MetroLink

Transport Infrastructure Ireland

Chapter 9 Erratum

ML1-JAI-TRA-ROUT_XX-RP-Z-00002 | P01.1

“The existing time plated operation of the bus lane can be continued within the northbound bus lane; this will allow for the existing drop-off to be continued during the period of the construction traffic management works”

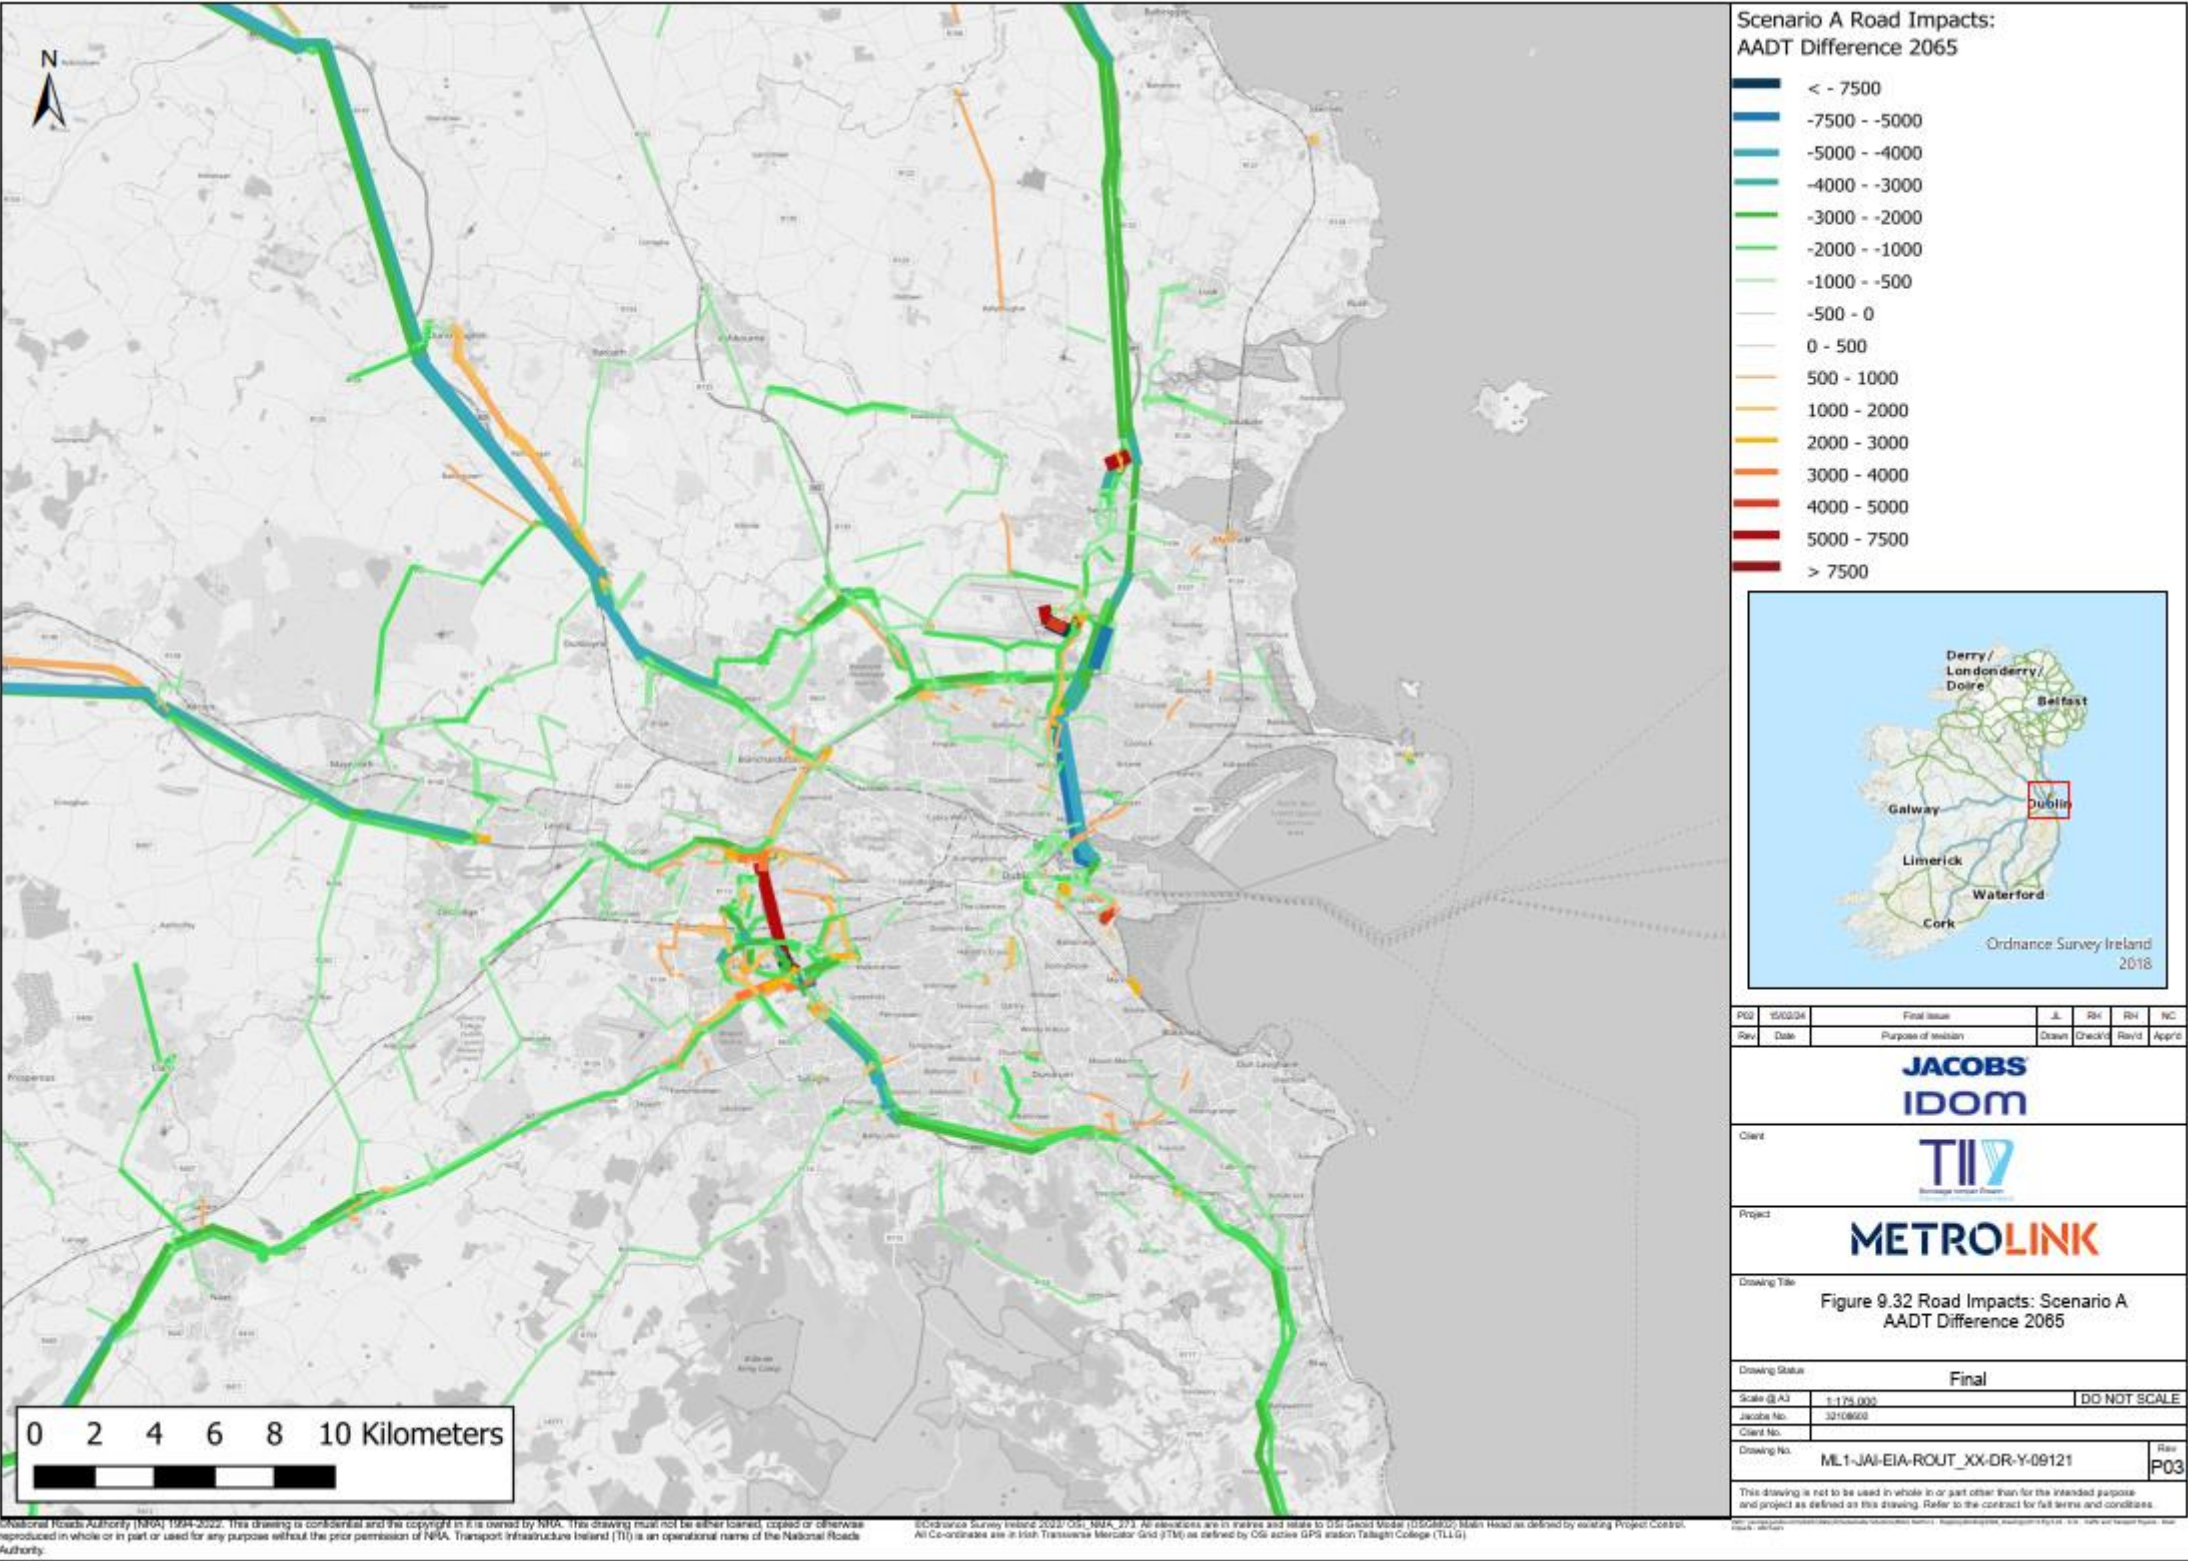
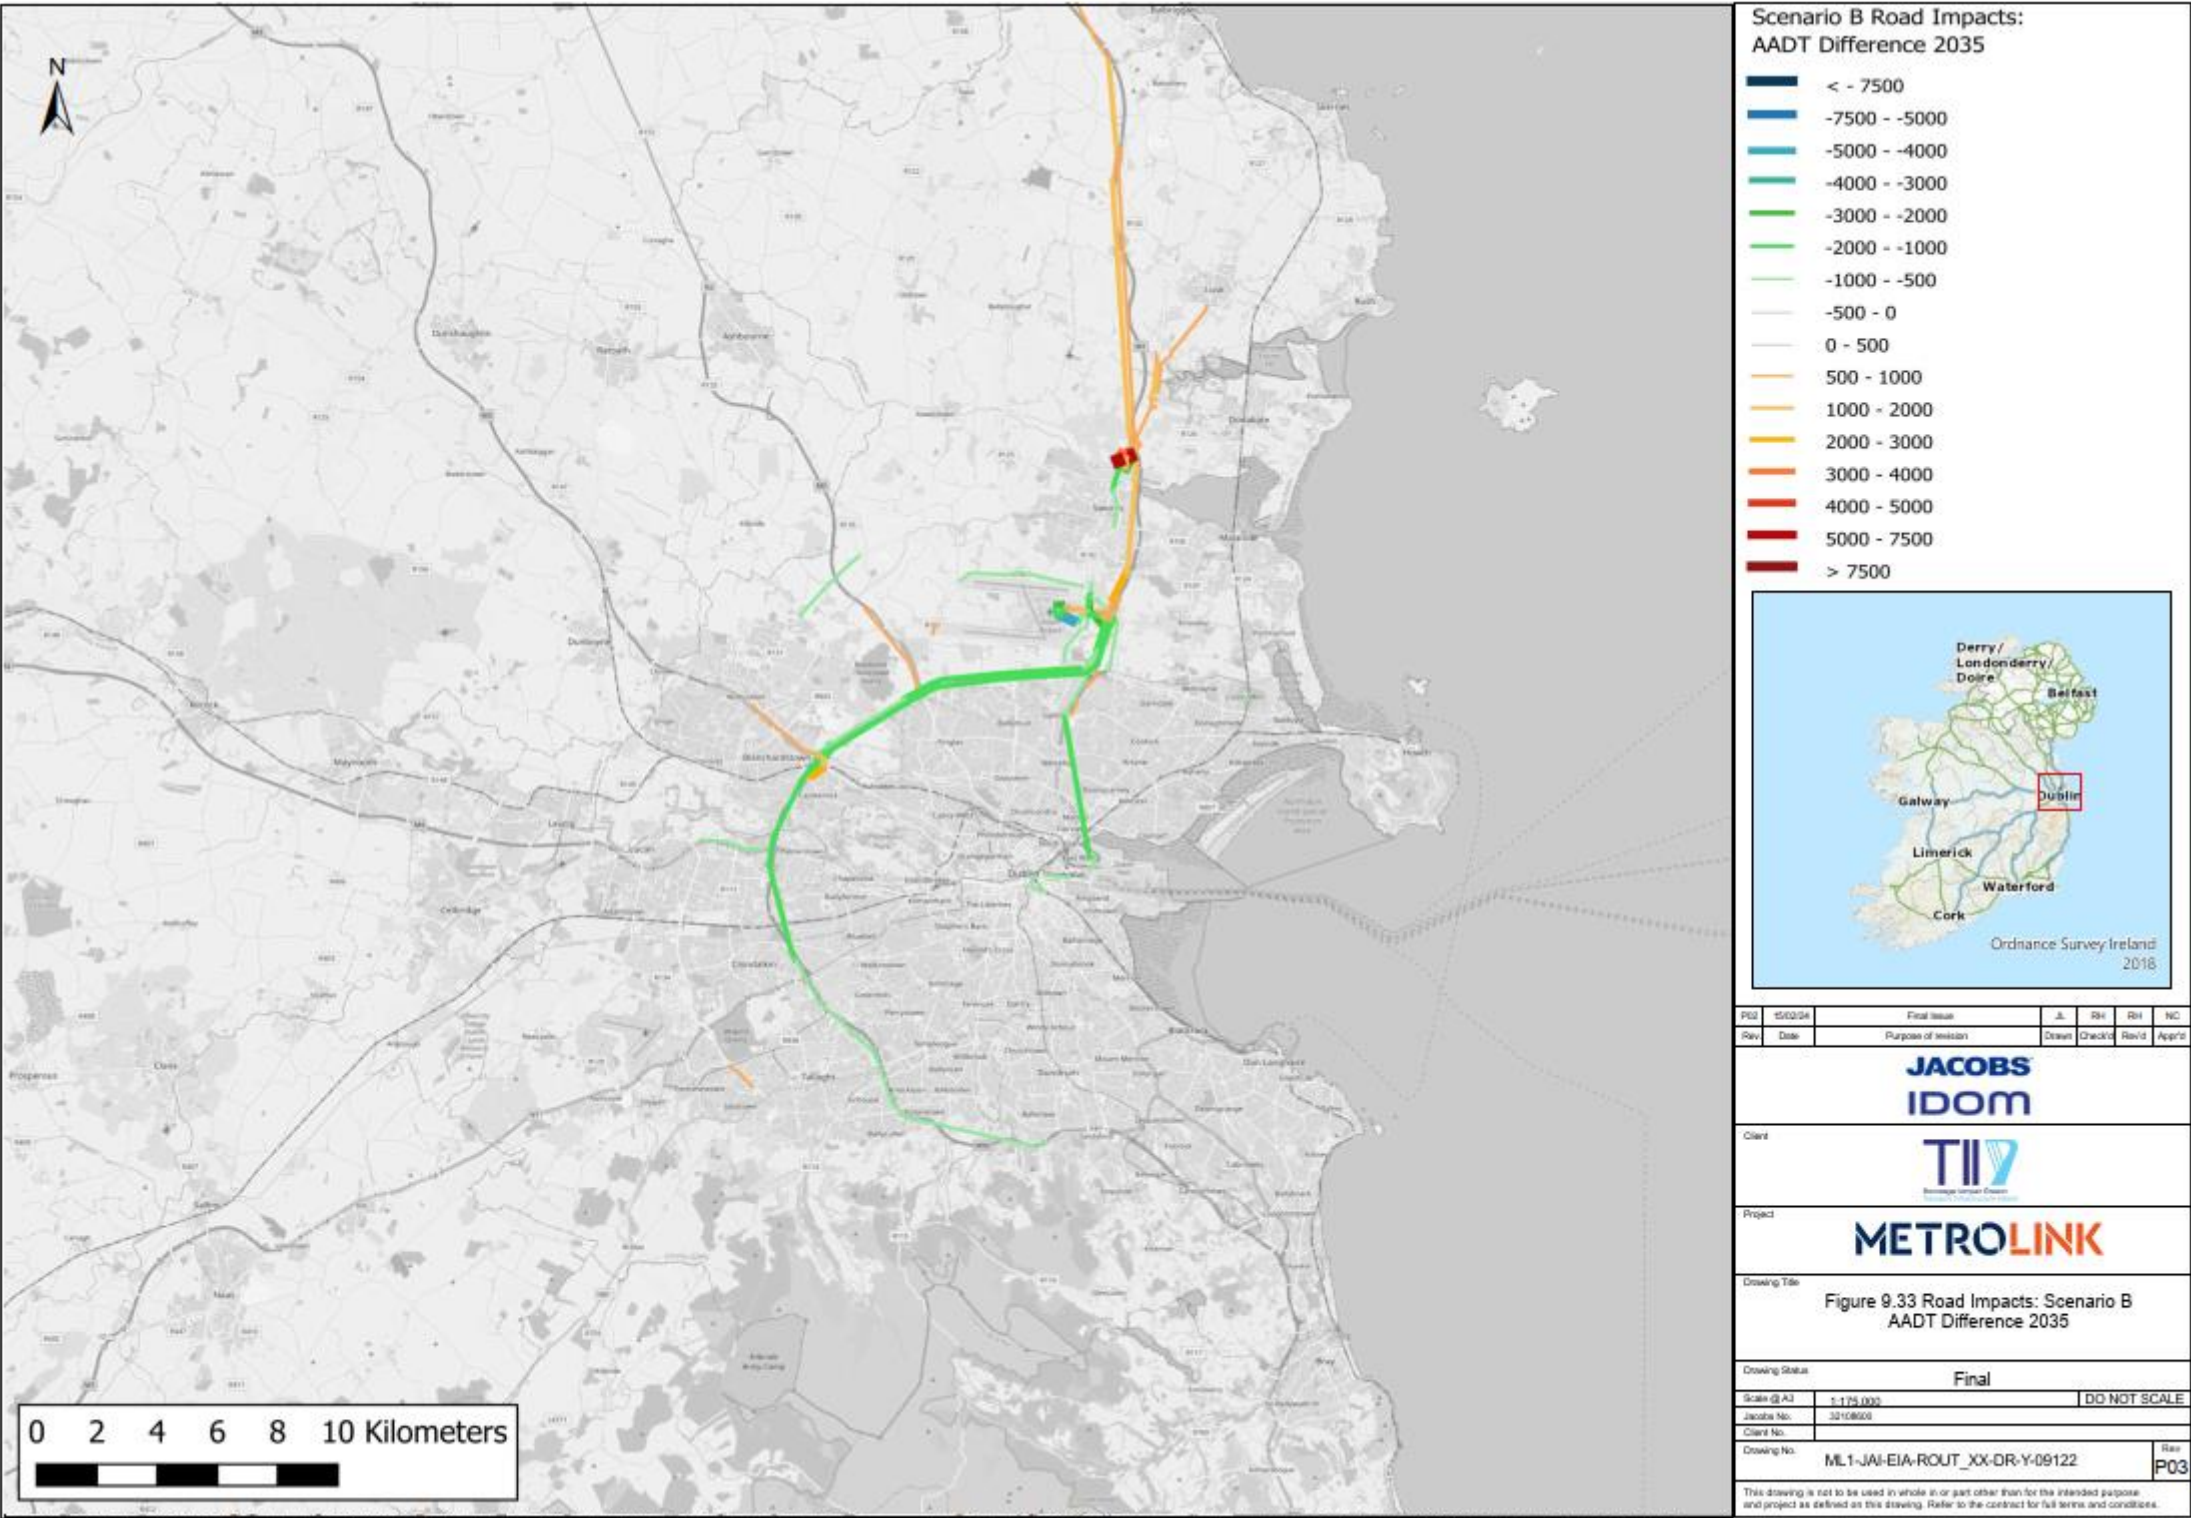
1.2.1 Reason for Change - Updates to Figures 9.30-9.35

The figures initially presented in the EIAR did not present the information in a clear and easy to understand manner. As a result, the images have been reproduced using the same information as before but using a different colour grading scale. Images are in the appendix below.

The below figures are the updates maps for figures 9.30 – 9.35 within chapter 9 of the EIAR.
